Pre-Application Conference Request
PLA-ANNX 2024-08

Project Name
750/790 SE Neck Rd

Property Line Adjustment, Annexation and Cottage Clusters

RE: Pre-Application Meeting Narrative and Questions for 750 and 790 Neck Road

PRELIMINARY EXISTING CONDITIONS PLAN
750 & 790 SE NECK RD
DAYTON, OREGON

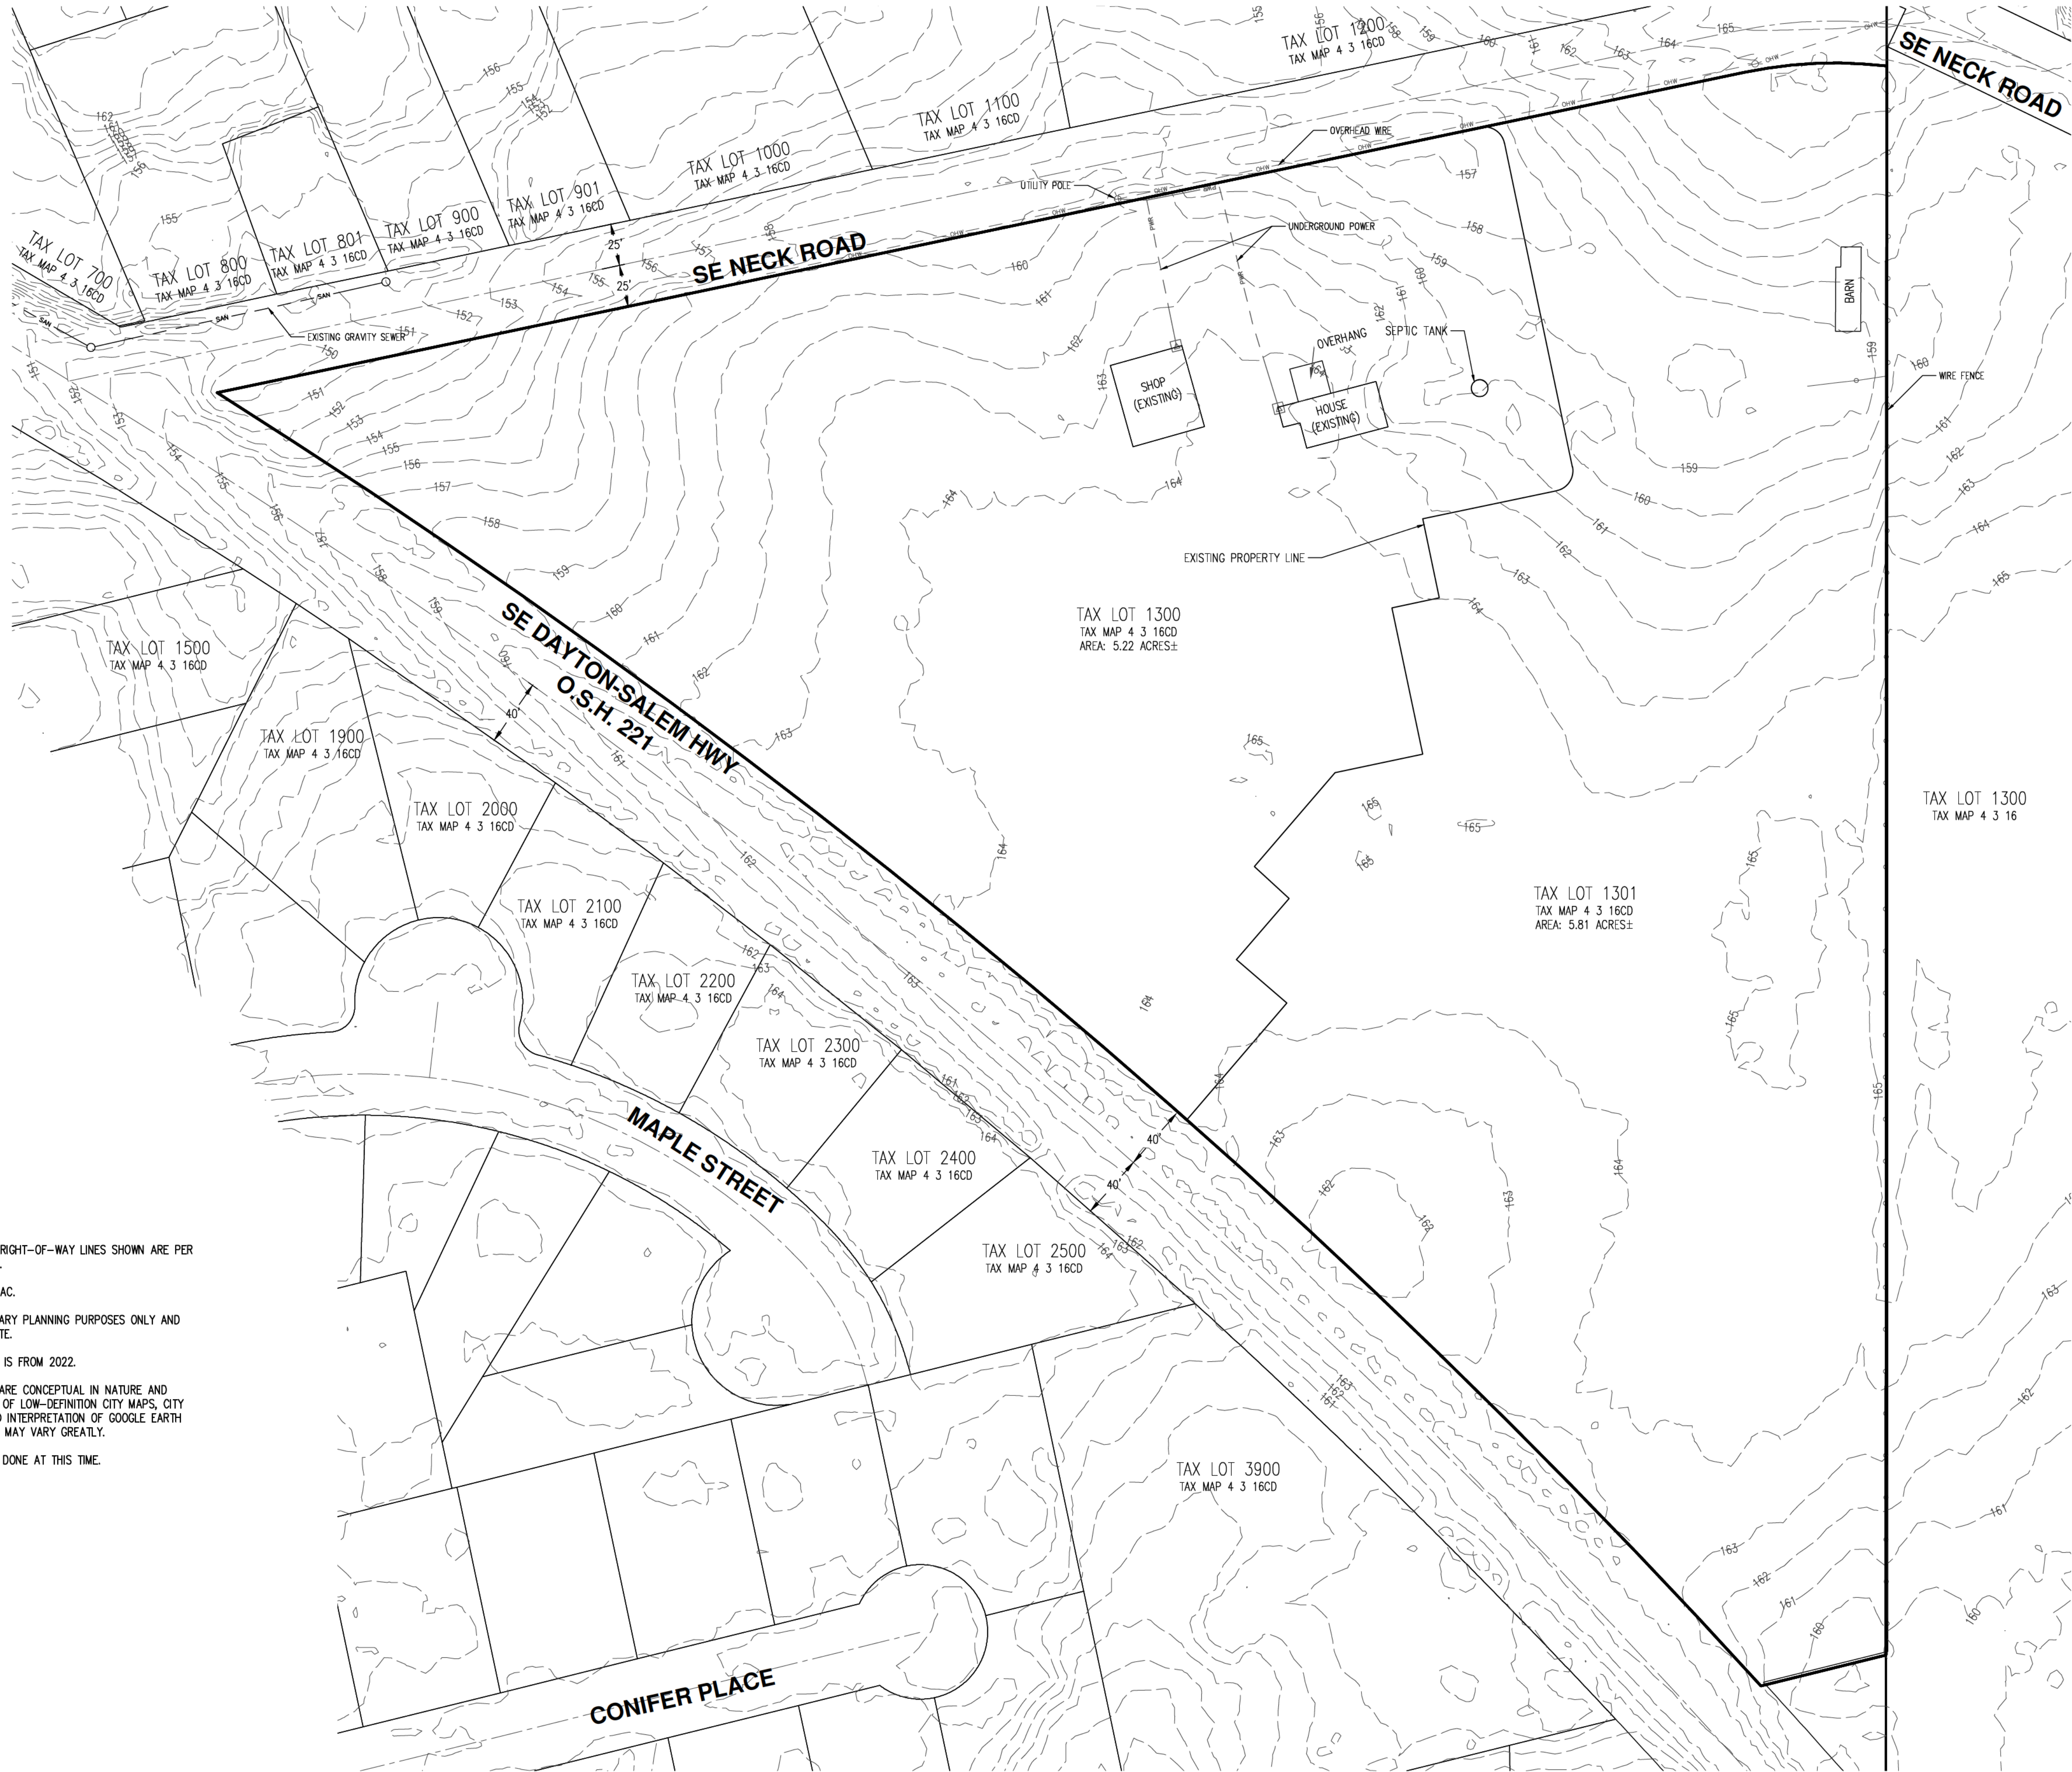
3. Please confirm the Preliminary Cottage Cluster Layout meets (or can meet) applicable City development and design standards (density, lot areas, dimensions, circulation, access, parking, open space, etc).

Planning Response: The conceptual layout lacks sufficient detail to confirm what standards will apply. It appears that a number of different options for dividing the property are under consideration. The standards that will apply will depend on how the development team chooses to permit the project and what applications are submitted. A subdivision or PUD are options for dividing the property with Site Development Review required for lots where multiple-family development is proposed. The development

team should review the density standards in Section 7.2.103.06.F and the General Development Standards 7.2.3 when deciding on how to proceed with the project.

SUBDIVISION LAYOUT

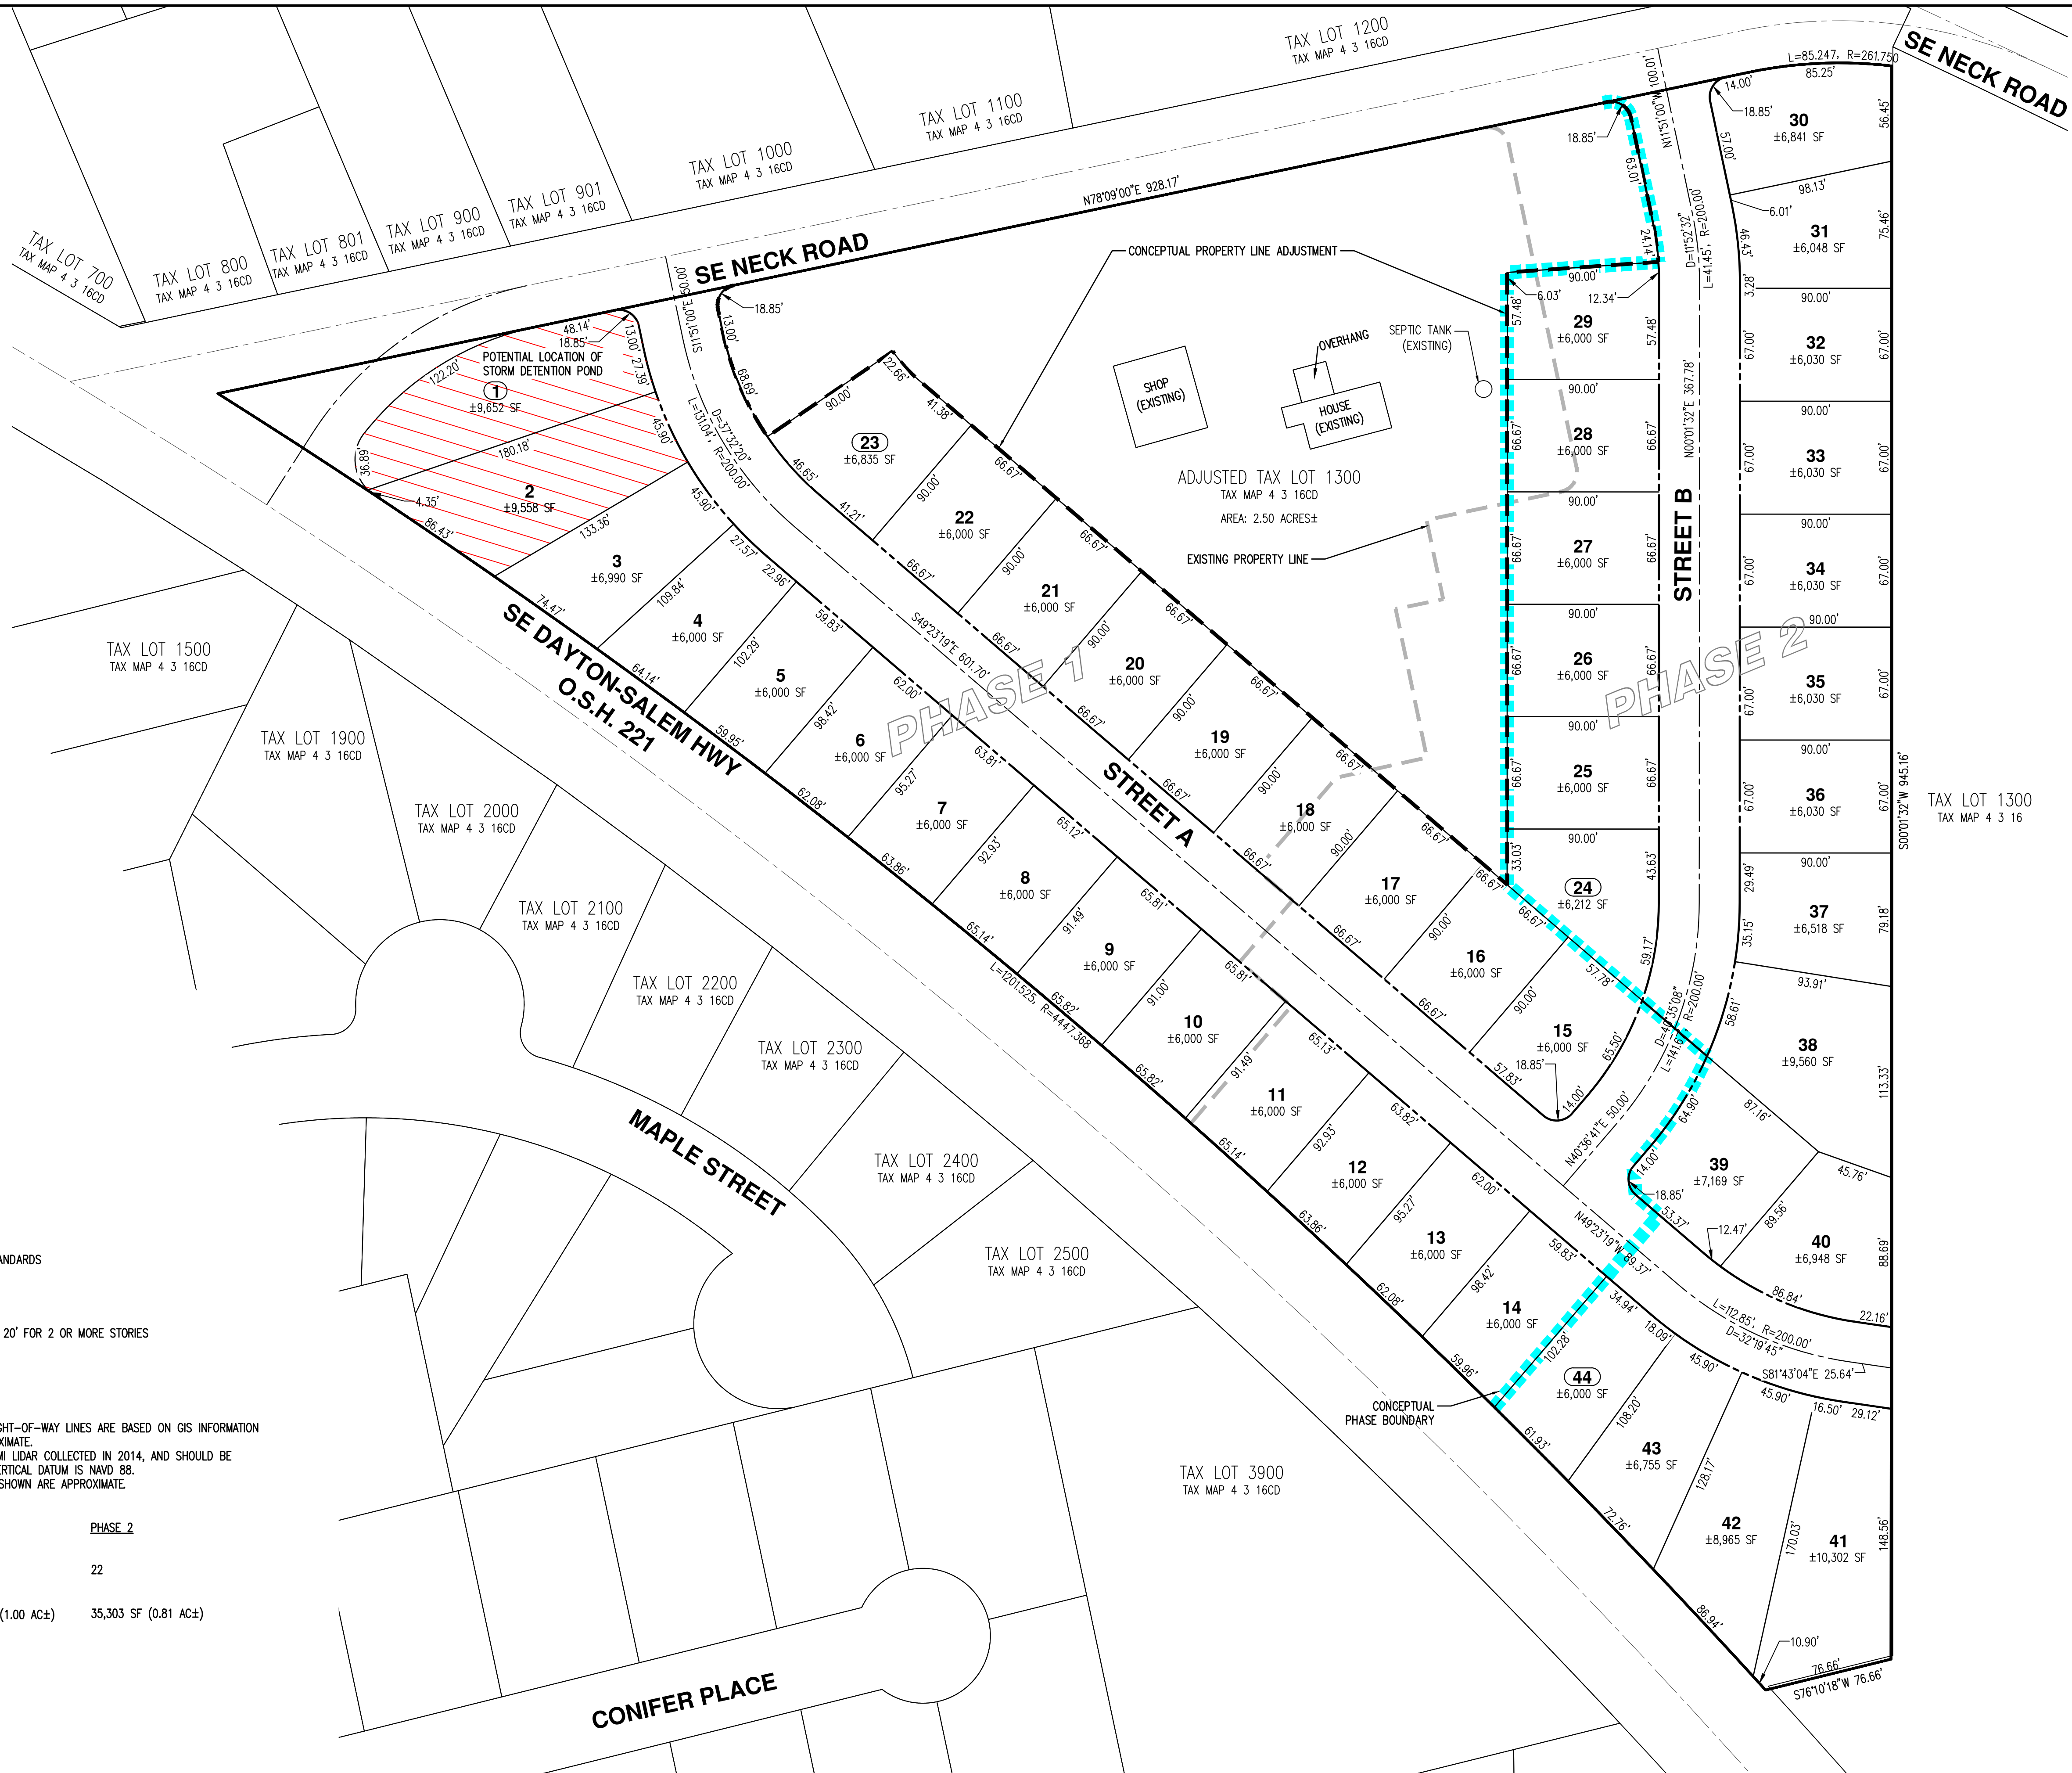
11. As discussed in the previous preapplication meetings, the intersection will need to be configured to meet current City and ODOT standards, similar to the conceptual layout provided with the previous subdivision application (see attached drawings from 2023). While the specific design for this previous intersection reconfiguration proposal has not been reviewed or commented on in detail (by either Dayton PW or ODOT), the concept illustrates the concept discussed by the City and ODOT, to make the actual intersection perpendicular with the highway.
